#### NOTICE OF A REGULAR MEETING BONDURANT PLANNING AND ZONING COMMISSION AUGUST 8, 2019

## PLANNING AND ZONING COMMISSION RESOLUTION NO. PZ-190808-17

BONDURANT, IOWA 89 PAINE STREET SE SITE PLAN REVIEW COMMENTS

#### 89 Paine Street SE Site Plan First Submittal

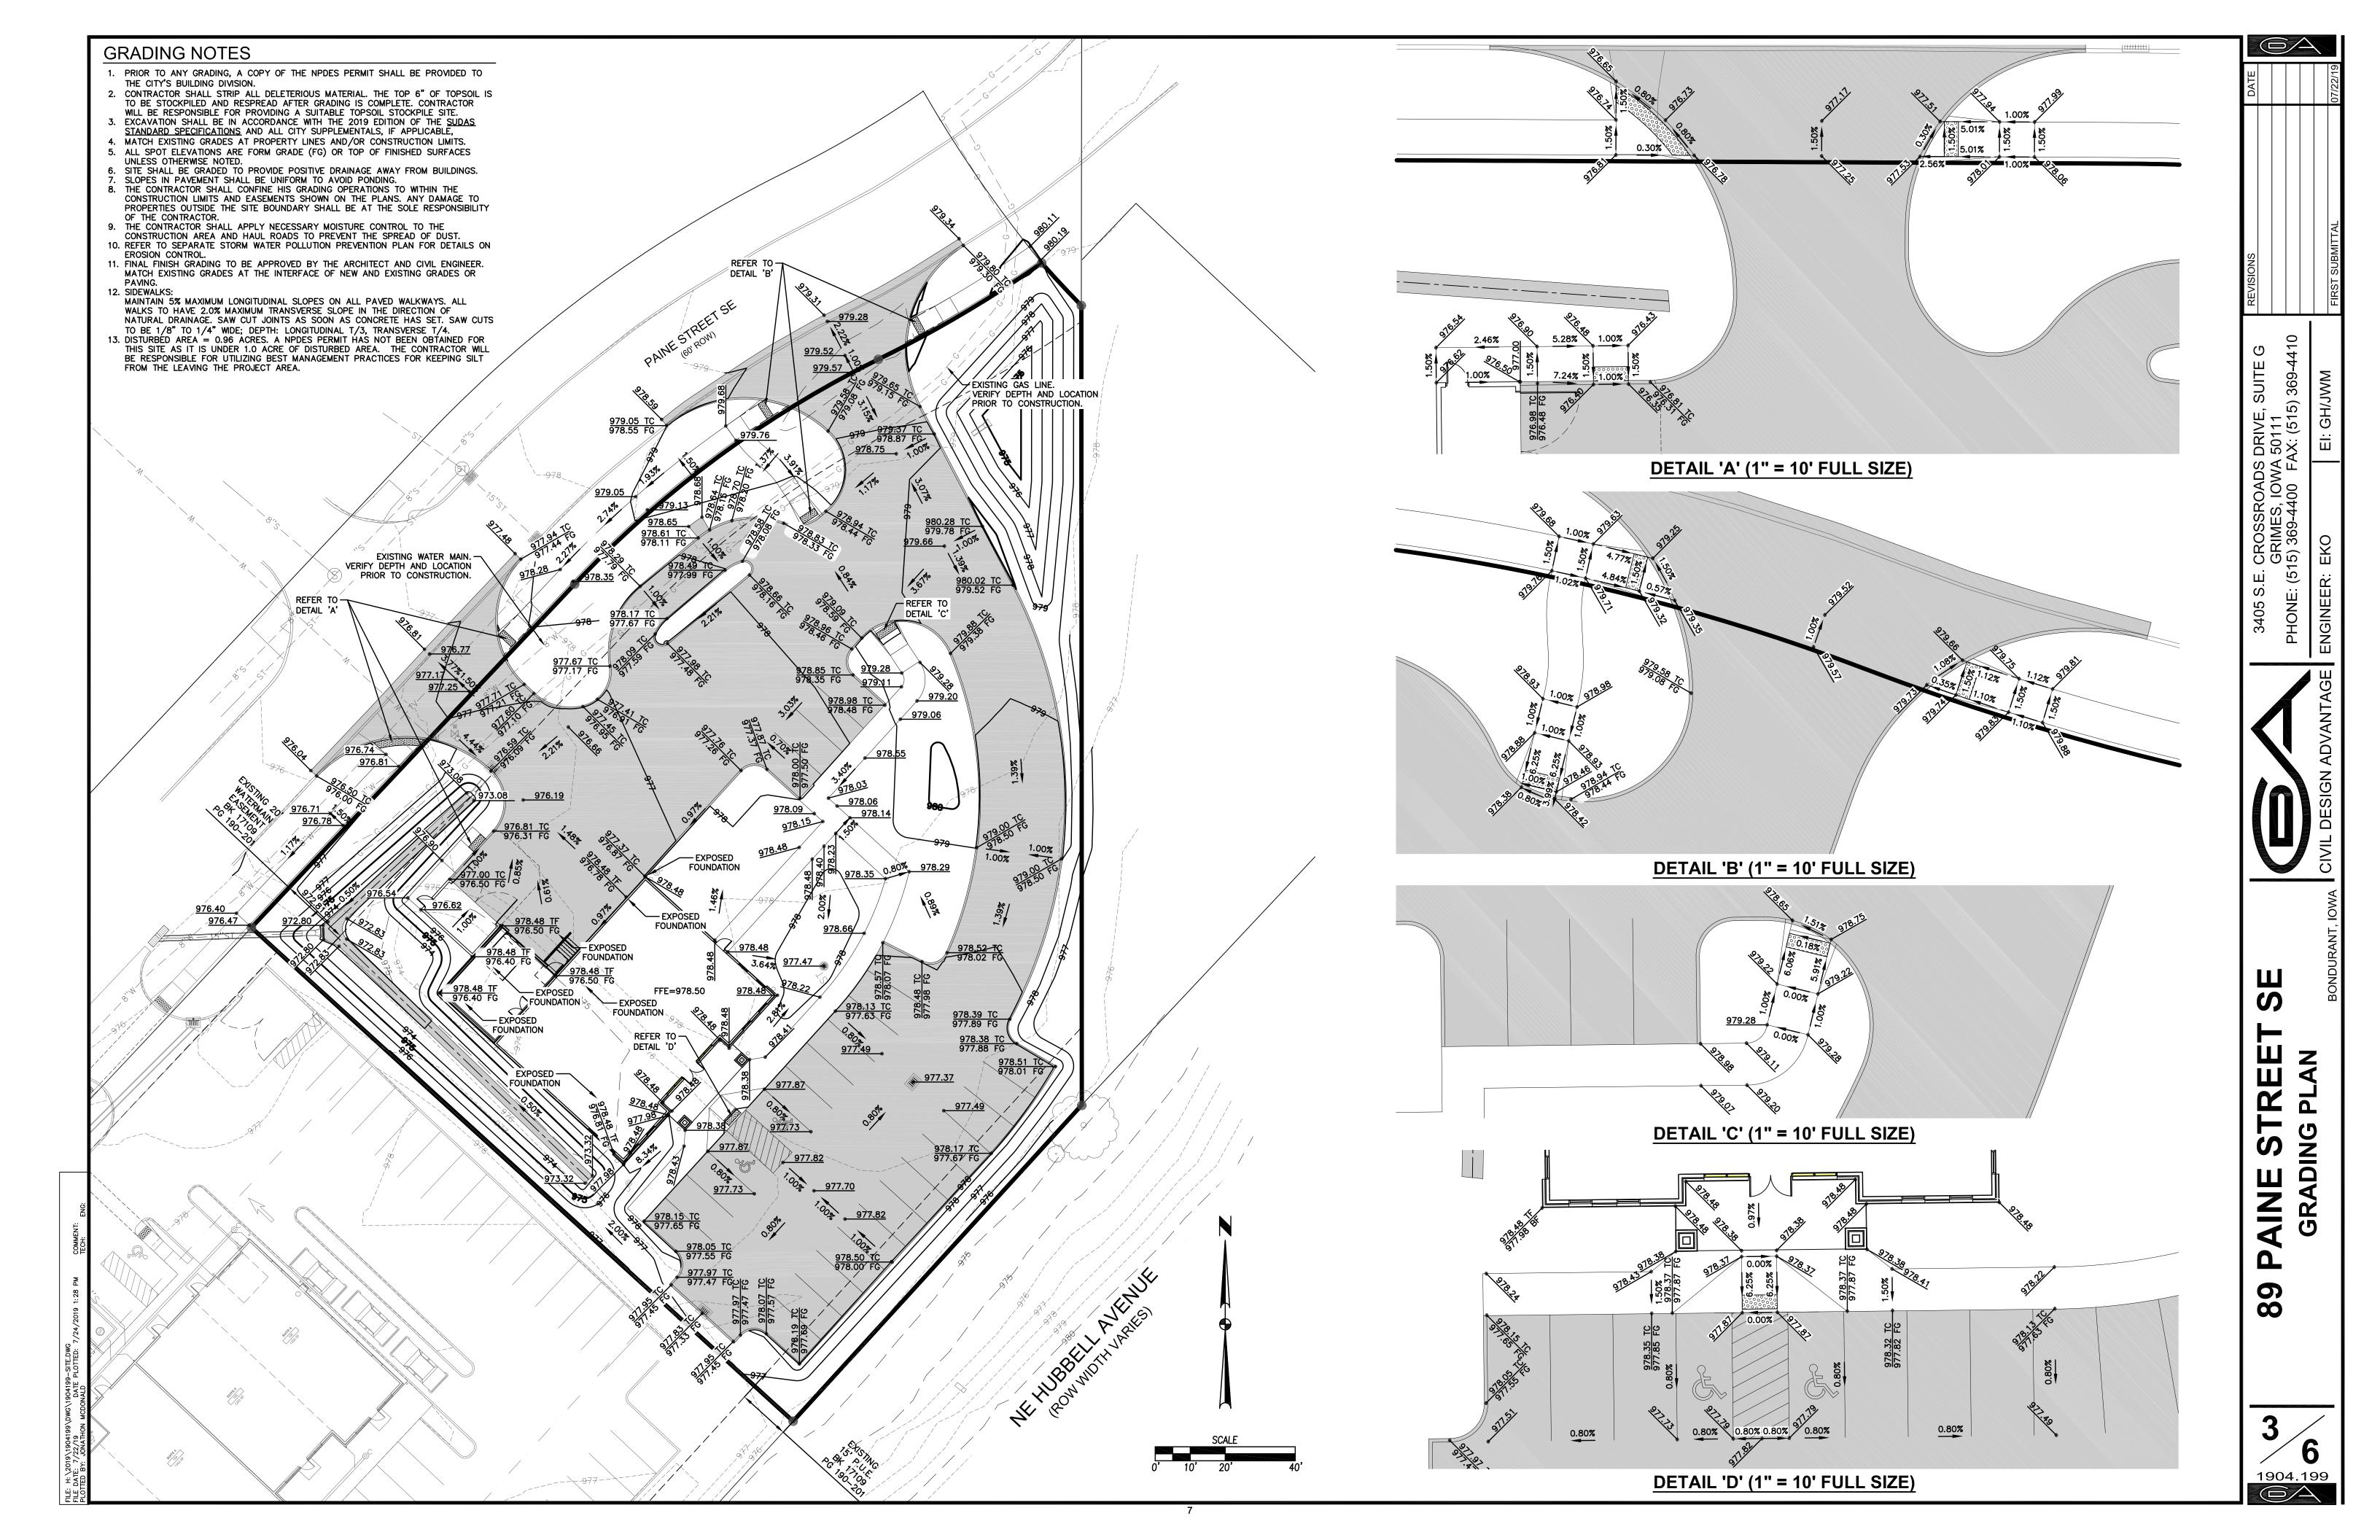
- 3. The site plan indicates the zoning at 89 Paine Street SE is C-2. The bulk regulations are shown on the site plan.
- 4. The site plan notes if the property is adjacent to an R district a buffer that meets one of the three options is to be provided. Outlot X in Paine Heights Plat 3 is zoned as R-2. It would appear the zoning ordinance would require a buffer as 89 Paine Street SE adjoins a residential lot even though that lot by itself may not be developable. The site plan does not appear to provide a buffer.

- 5. The site plan shows a portion of the water main along the easterly side of Paine Street SE. The water main depiction ends near the center of the lot. The water main continues northeasterly across Paine Street SE. The site plan should show the balance of the water main.

- 8. The site plan indicates a total of 27 parking stalls will be provided. The required minimum number of parking stalls is 25.
- The site plan indicates two handicap accessible parking stalls provided near the front entrance of the building. Two handicap accessible parking stalls are required.

- 12. The site plan indicates on the northwesterly side of the building there appears to be a drive-thru drop off as well as four parking stalls. The majority of the parking stalls are located on the southeasterly side of the building.

- 15. The site plan includes sidewalk access both to the northeasterly and southeasterly faces of the new building.
- 16. The site plan includes an erosion control plan. The site will disturb more than one acre. The applicant will need to obtain a General Permit No. 2 from the Iowa Department of Natural Resources. A copy of the Storm Water Pollution Prevention Plan and the General Permit No. 2 will need to be provided to the City prior to the start of construction.
